SUBJECT: WATERFORD STEAM ELECTRIC STATION, UNIT 3 - ISSUANCE OF  
AMENDMENT RE: MODIFY TS 5.6, "FUEL STORAGE"; ADD NEW  
TS 3/4.9.12, "SPENT FUEL POOL BORON CONCENTRATION," AND  
TS 3/4.9.13, "SPENT FUEL STORAGE" (TAC NO. MD9685)

Amendment No. 223  
License No. NPF-38

SAFETY EVALUATION BY THE OFFICE OF NUCLEAR REACTOR REGULATION

WATERFORD STEAM ELECTRIC STATION, UNIT 3

Figure 5.6-1 Alternative Checkerboard Storage Arrangements

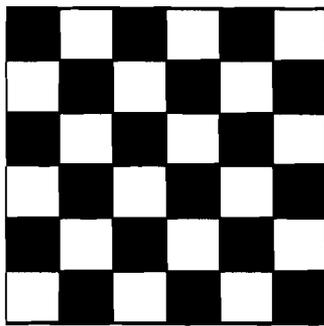
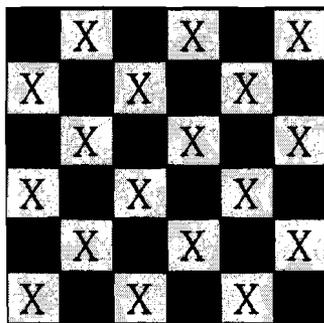
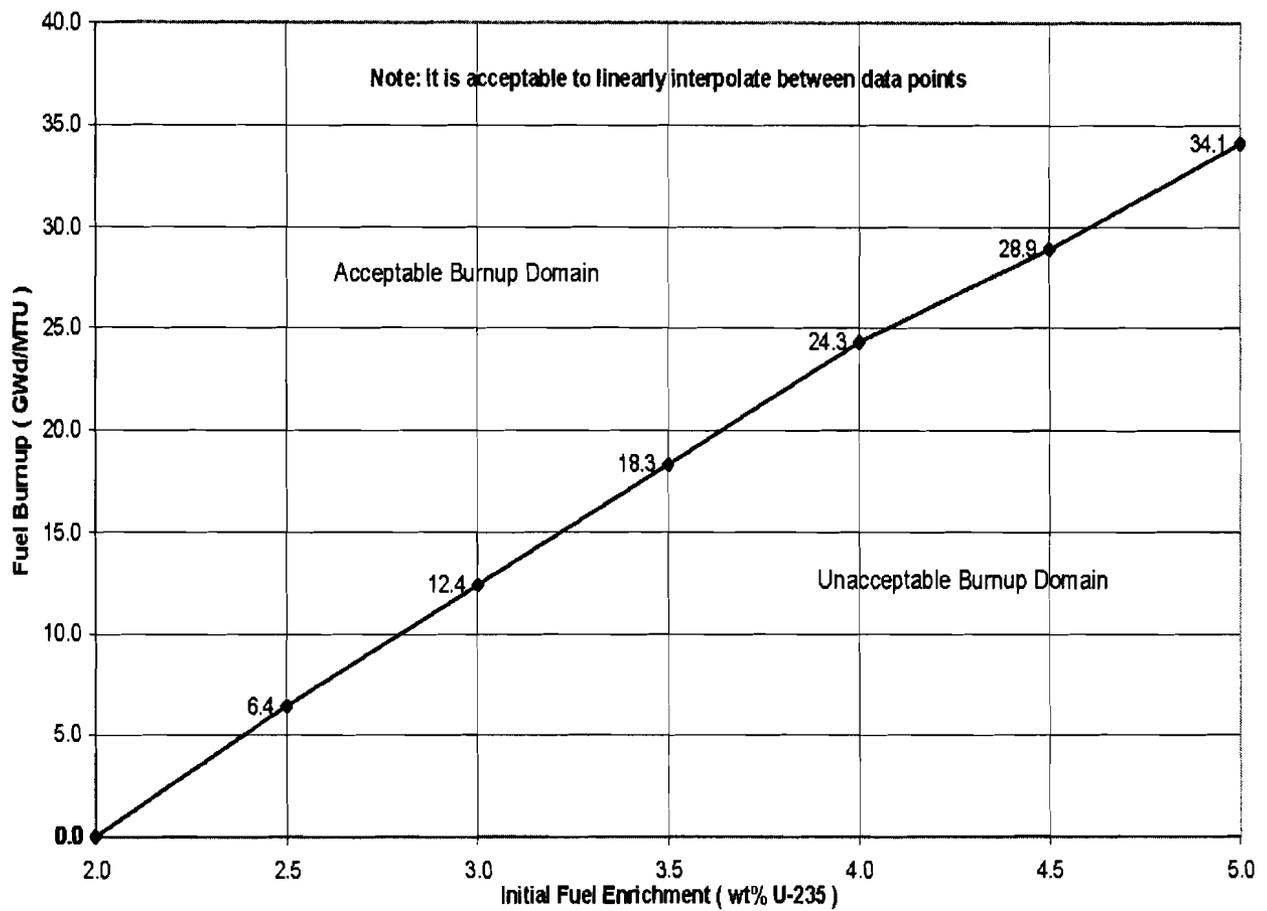
7. TS Figure 5.6-1 will be replaced by a new Figure 5.6-1 to show the new Alternative Checkerboard Storage Arrangements.

Fresh fuel assemblies may be stored in the Region 2 racks provided that they are stored in a "checkerboard pattern" with empty cells as illustrated in Figure 5.6-1, Pattern 1. Irradiated fuel assemblies with any burnup may also be stored with empty cells in the checkerboard configuration of Figure 5.6-1, Pattern 1.

Irradiated fuel assemblies with a burnup of  $\geq 27$  GWd/MTU [gigawatt days per metric ton unit] in the "unacceptable range" of Figure 5.6-2 may be stored in the Region 2 racks in a "checkerboard pattern," as illustrated in Figure 5.6-1, Pattern 2 with irradiated fuel in the "acceptable range" of Figure 5.6-3.

Figure 5.6-2 Acceptable Burnup Domain for Unrestricted Storage of Irradiated Fuel in Region 2 of the Spent Fuel Pool

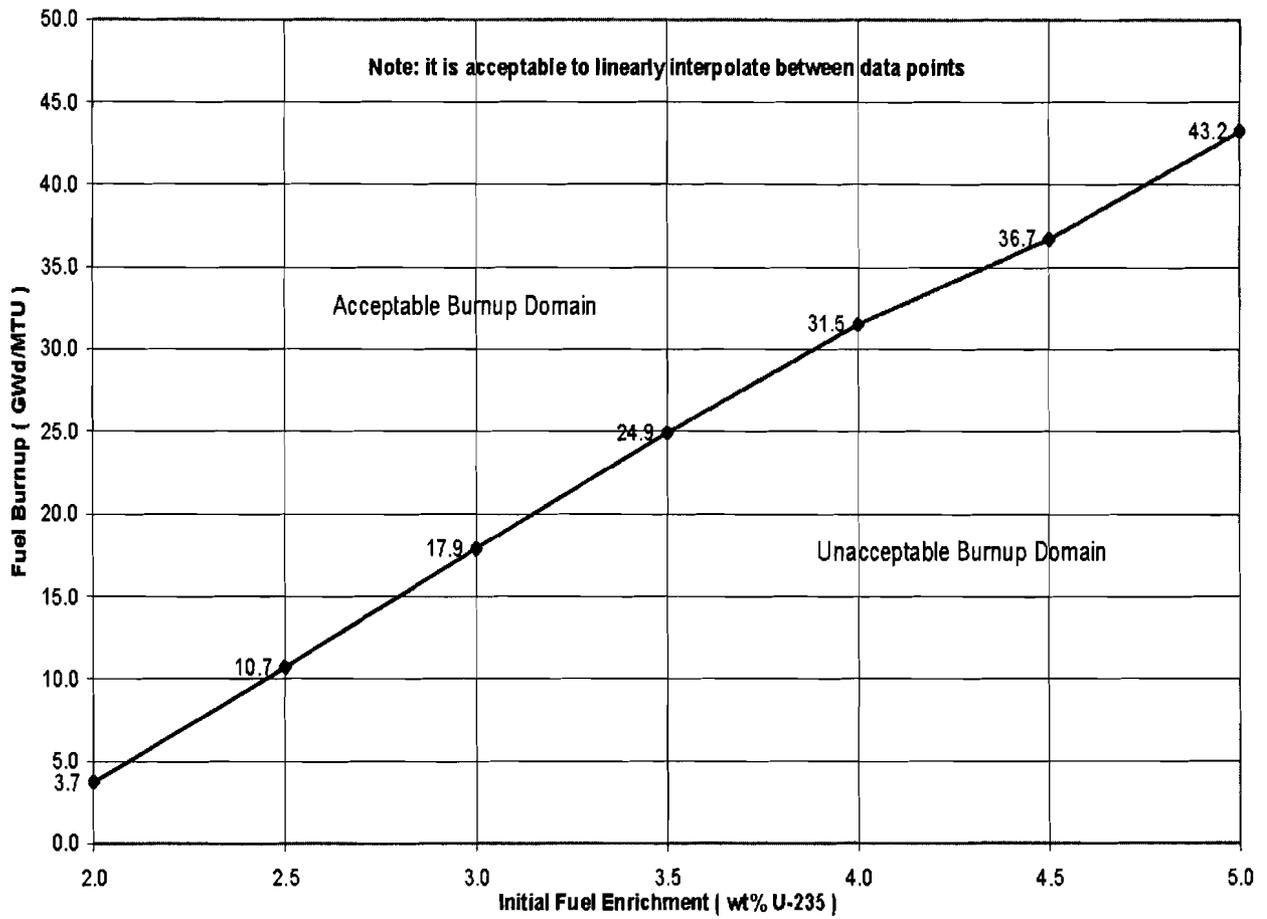
8. TS Figure 5.6-2 will be replaced by a new Figure 5.6-2 to show the new Acceptable Burnup Domain for Unrestricted Storage of Irradiated Fuel in Region 2 of the Spent Fuel Pool.

Irradiated fuel assemblies with a burnup in the "acceptable range" of Figure 5.6-2 may be allowed unrestricted storage in the Region 2 racks.

Figure 5.6-3 Acceptable Burnup Domain for Irradiated Fuel in a Checkerboard Arrangement with Fuel of 5 wt% Enrichment, or Less, at 27 GWd/MTU Burnup, or Higher, in Region 2 of the Spent Fuel Pool

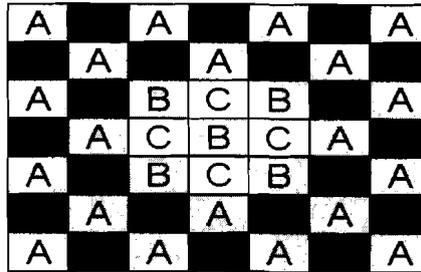
9. TS Figure 5.6-3 will be replaced by a new Figure 5.6-3 to show the Acceptable Burnup Domain for Irradiated Fuel in a Checkerboard Arrangement with Fuel of 5 wt % [weight percent] Enrichment, or less, at 27 GWd/MTU Burnup, or higher, in Region 2 of the Spent Fuel Pool.

Figure 5.6-4 Examples of Contiguous Checkerboard Configurations Which Meet Interface Requirements

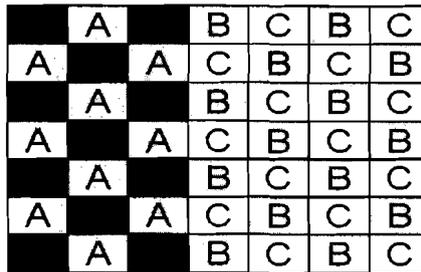
10. A new TS Figure, TS Figure 5.6-4, will be added to show Examples of Contiguous Checkerboard Configurations Which Meet Interface Requirements.
